## REVISION TRANSMITTAL

This sheet transmits Revision 1 to SB525B-34-40, which:

NAVIGATION - GARMIN HARDWARE AND SOFTWARE UPDATE TO VERSION 4.8.9

SB525B-34-40  
Page 1 of 23

Figure 1. Wiring Modification (Sheet 1)

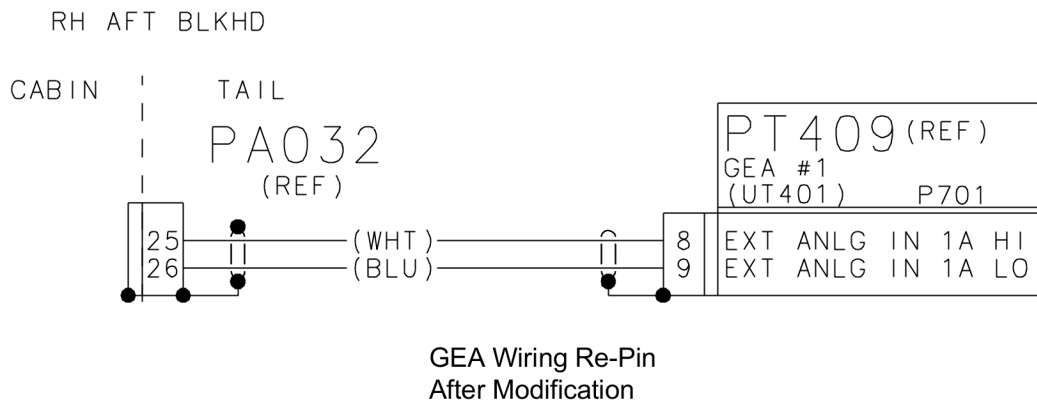
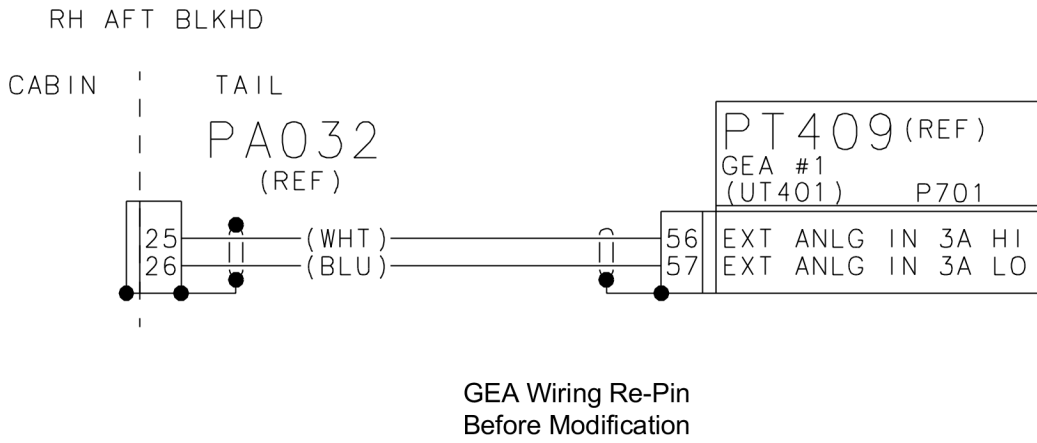
- B. (Airplanes equipped with the Stormscope option) (Refer to Figure 1, Sheet 1.) Modify the wiring.
- (1) Open the left nose baggage compartment door.

- (5) Remove the PN836 electrical connector from the Stormscope Processor.
  - (6) Remove the PN409 electrical connector from the left avionics pallet.

- (7) Install the 26PN836-77PN409 Electrical Wire with two M39029/58-362 Connector Pins.
  - (8) Install the 77J3-70P606 Electrical Wire using two M39029/58-362 Connector Pins.

- (9) Install the PN836 Electrical Connector in the Stormscope Processor.
  - (10) Install the PN409 electrical connector in the left avionics pallet.

Figure 1. Wiring Modification (Sheet 3)

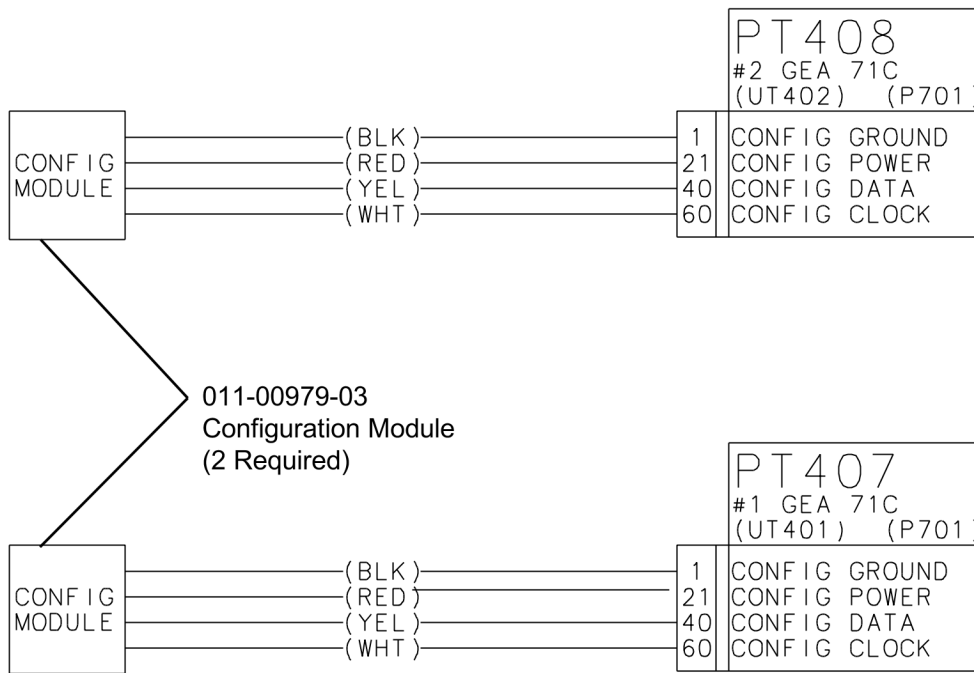
- B. (Refer to Figure 1, Sheet 3.) Do the DME Option Wiring Modification. (Refer to the Citation Standard Practices Manual, Chapter 20, Splices, Terminals and Heat Shrinkable Tubing - Maintenance Practices.)

- (1) Remove the electrical wire from pins 74PI548 and 75PI548 and install in pins 31PI548 and 52PI548.
    - (2) Remove the electrical wire from pins 15PI523 and 16PI523 and install in pins 54PI523 and 55PI523.

Figure 1. Wiring Modification (Sheet 5)

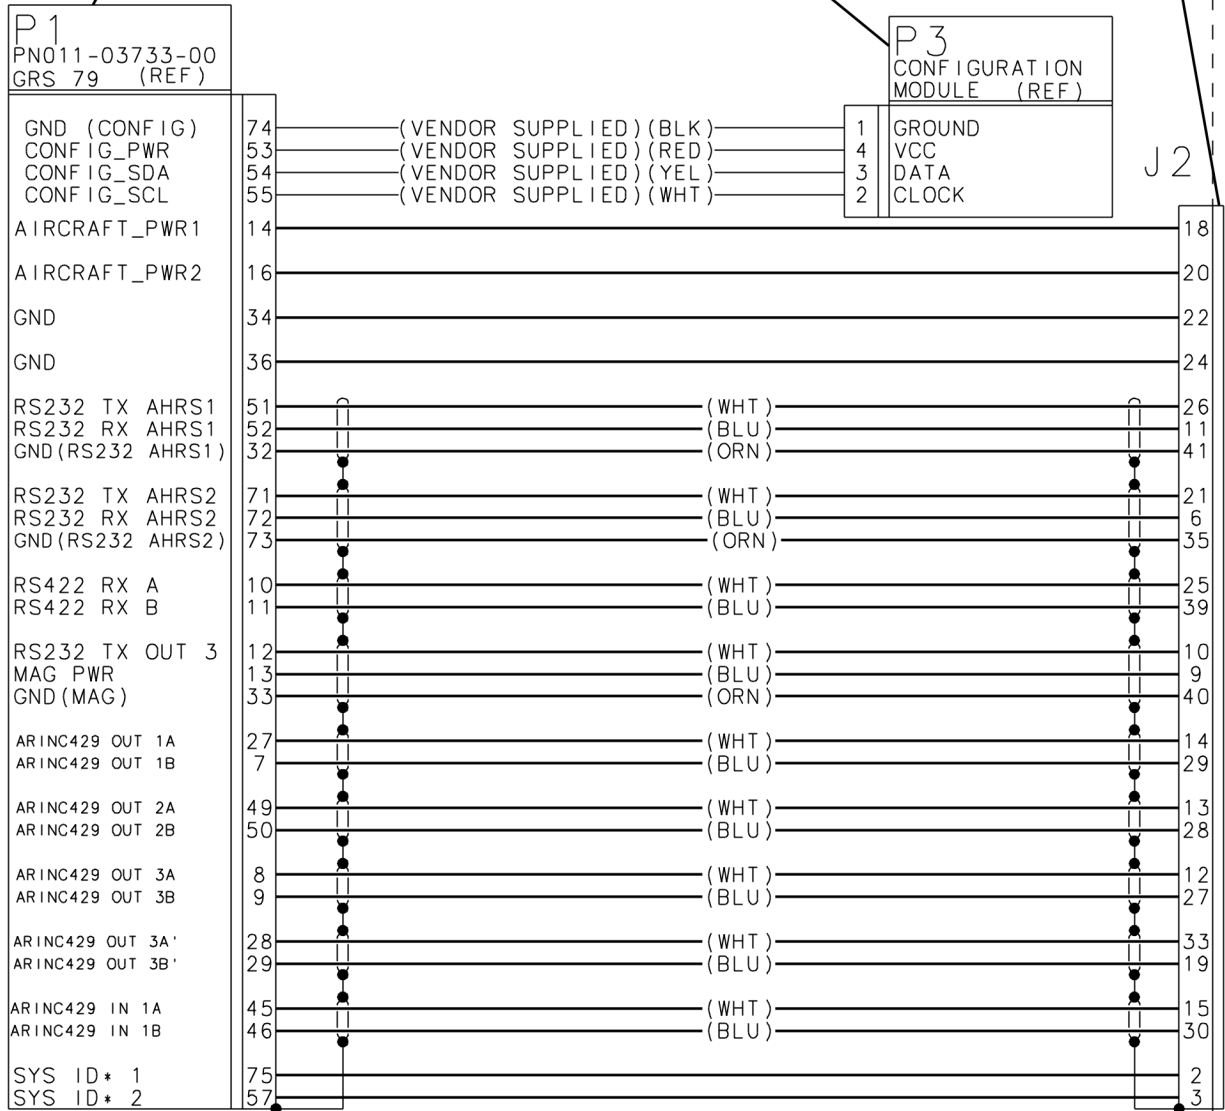
- (1) Install the wires.

- (a) Install the 14P1-18J2 Electrical Wire in the DD44S00GV30 Hi Density 44S Connector using one M39029/57-354 Socket Contact.
- (b) Install the 16P1-20J2 Electrical Wire in the DD44S00GV30 Hi Density 44S Connector using one M39029/57-354 Socket Contact
- (c) Install the 34P1-22J2 Electrical Wire in the DD44S00GV30 Hi Density 44S Connector using one M39029/57-354 Socket Contact
- (d) Install the 36P1-24J2 Electrical Wire in the DD44S00GV30 Hi Density 44S Connector using one M39029/57-354 Socket Contact

- (e) Install the 51P1-26J2 (WHT), 52P1-11J2 (BLU), 32P1-41J2 (ORN) Electrical Wire in the DD44S00GV30 Hi Density 44S Connector using three M39029/57-354 Socket Contacts and one S2974-8 Shield Termination.

- (f) Install the 71P1-21J2 (WHT), 72P1-6J2 (BLU), 73P1-35J2 (ORN)] Electrical Wires in the DD44S00GV30 Hi Density 44S Connector using three M39029/57-354 Socket Contacts and one S2974-8 Shield Termination,

Figure 1. Wiring Modification (Sheet 6)

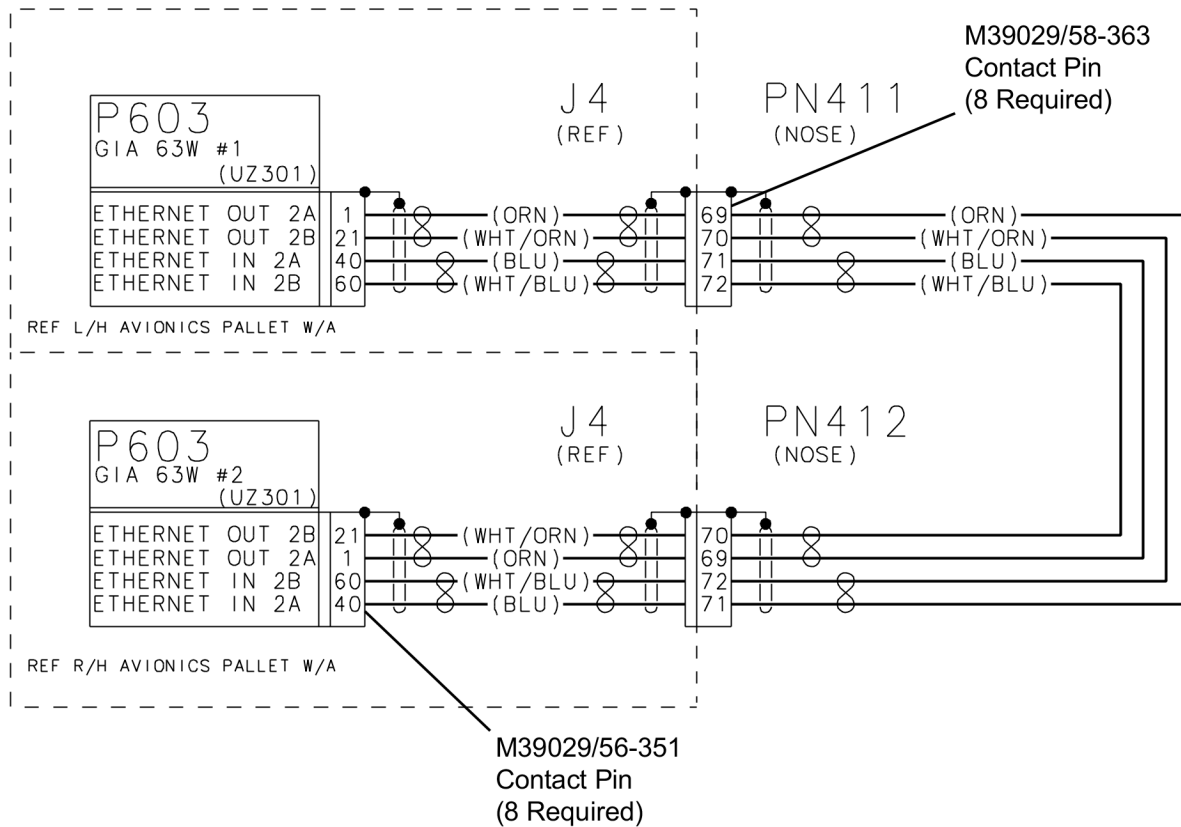
- C. (Refer to Figure 1, Sheet 6.) Do the GIA 64E Wiring Modification. (Refer to the Citation Standard Practices Manual, Chapter 20, Splices, Terminals and Heat Shrinkable Tubing - Maintenance Practices.)

- (1) Install the 1P603-69J4 (ORN), 21P603-70J4 (WHT/ORN), 40P603-71J4 (BLU), 60P603-72J4 (WHT/BLU)] Ethernet Cable with four M39029/56-351 Contacts, four M39029/58-363 Contact Pins and two S2974-8 Shield Terminations.

- (2) Install the 21P603-70J4 (WHT/ORN), 1P603-69J4 (ORN), 60P603-72J4 (WHT/BLU), 40P603-71J4 (BLU) Ethernet Cable with four M39029/56-351 Contacts, four M39029/58-363 Contact Pins and two S2974-8 Shield Terminations.

- (3) Install the 69PN411-71PN412 (ORN), 70PN411-72PN412 (WHT/ ORN), 71PN411-69PN412 (BLU), 72PN411-70PN412 (WHT/BLU) Ethernet Cable with four M39029/56-351 Contacts, four M39029/58-363 Contact Pins and two S2974-8 Shield Terminations.

Figure 2. AHRs Remote Rack Installation (Sheet 1)

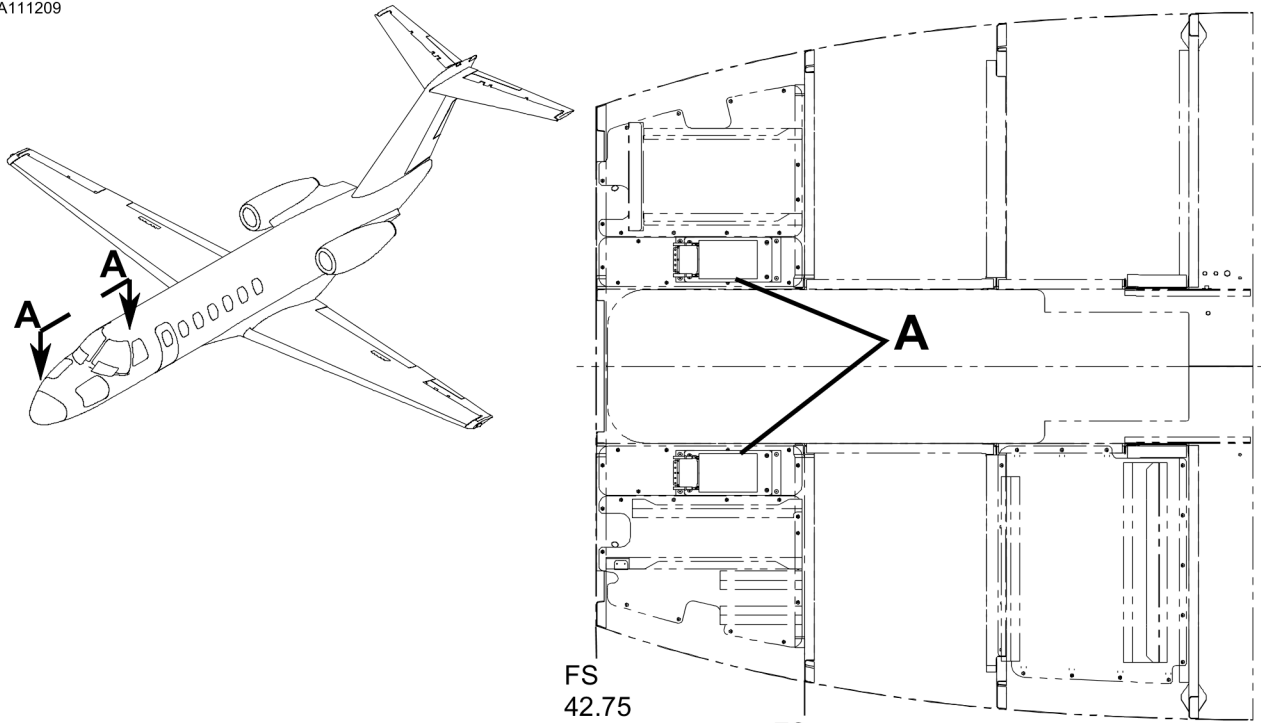
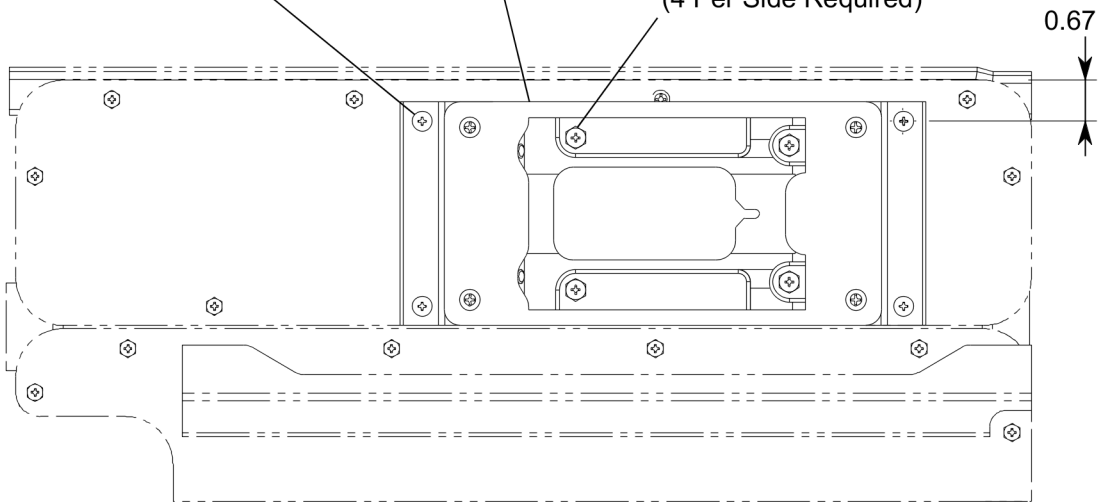
- A. Adds the installation of the 6397107-2 Channel Assembly and 6397107-3 Shelf Assembly to Step 7.C.
- B. Adds the 6397107-2 Channel Assembly and 6397107-3 Shelf Assembly to the MATERIAL INFORMATION section.
- C. Adds the 010-03722-00 TOLD Database Card to Step 13.B.
- D. Adds to discard the 010-03722-00 TOLD Database Card to the MATERIAL INFORMATION section.
- E. Adds instructions to Step 50 to replace the current 190-01742-01 Pilot's Guide with the new 190-02613-00 Pilot's Guide.
- F. Adds instructions to Step 50 to replace the current 190-01743-01 Cockpit Reference Guide with the new 190-02614-00 Cockpit Reference Guide.
- G. Adds Figure 2, Sheet 1 which shows the installation of the 6397107-2 Channel Assembly and 6397107-3 Shelf Assembly.

- C. (Refer to Figure 2 Detail A and View A-A.) Install two new 117-00608-00 GRS 79 Remote Racks.
  - (1) Remove and keep the MS27039-0808 Screws from the two 115-00459-00 GRS 77 Mounting Racks.
  - (2) Remove and discard the two 115-00459-00 GRS 77 Mounting Racks.
  - (3) Install two 6397107-2 Channel Assemblies with the kept MS27039-0808 Screws.
  - (4) Install the 6397107-3 Shelf Assembly with four MS35206-245 Screws.
  - (5) Install each 117-00608-00 GRS 79 Remote Rack with four NAS1801-3-8 Screws.
- D. Install the new 011-03732-00 GRS 79 AHRS Units. (Refer to the Model 525B Maintenance Manual, Chapter 34, Garmin GRS 77/79 AHRS Unit - Removal/Installation (Airplanes -0057 and -0451 and On.))
